RESPONSES TO FERC COMMENTS ON RESOURCE REPORT 1 & 11 FROM AUGUST 2015

**JACKSONVILLE PROJECT**

FERC DOCKET NO. CP17-\_\_\_\_-000 (PF15-7-000)

## **Responses to Federal Energy Regulatory Commission August 26, 2015 Comments on Jacksonville Project Draft Resource Report 1**

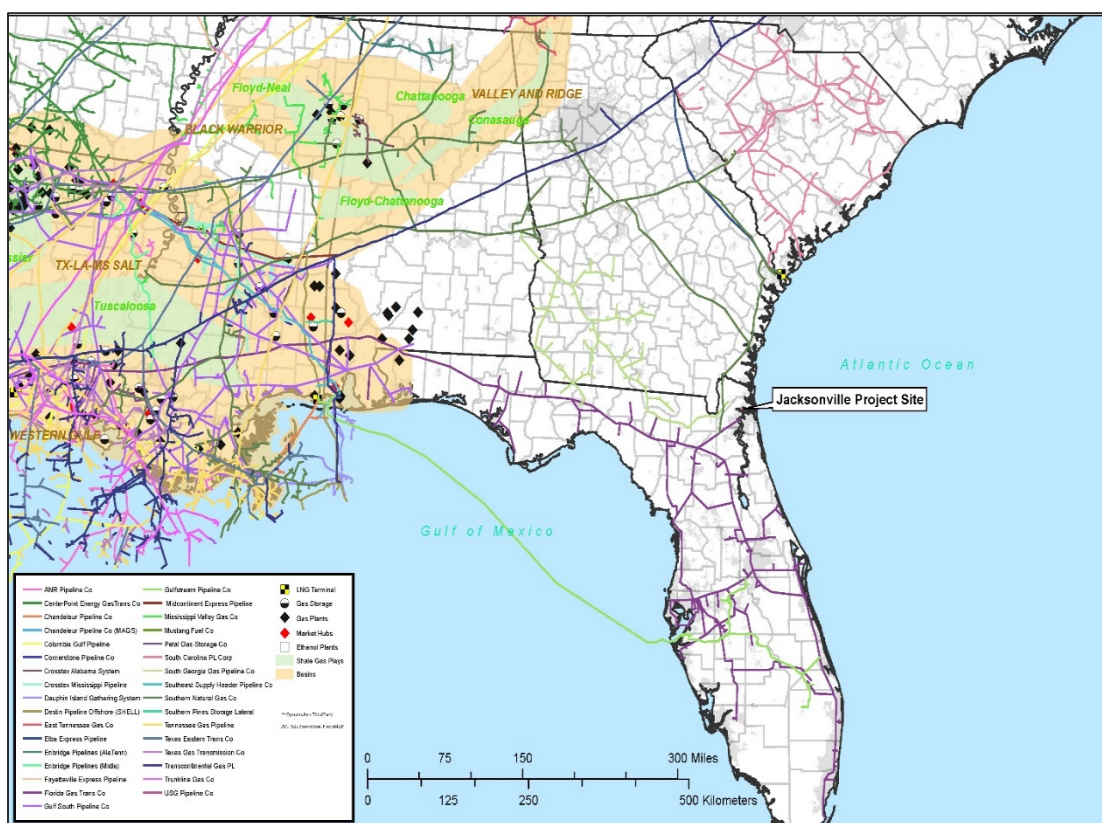
9. **Revise major gas pipeline system map to include labels and legends. Indicate the location of the proposed facilities on the map. (Figure 1-2.1, page 11)**

The major gas pipeline system map has been revised to include labels, a legend, and the location of the proposed Project and is provided below. The revised figure is included as Figure 1.2-1 in Resource Report 1.
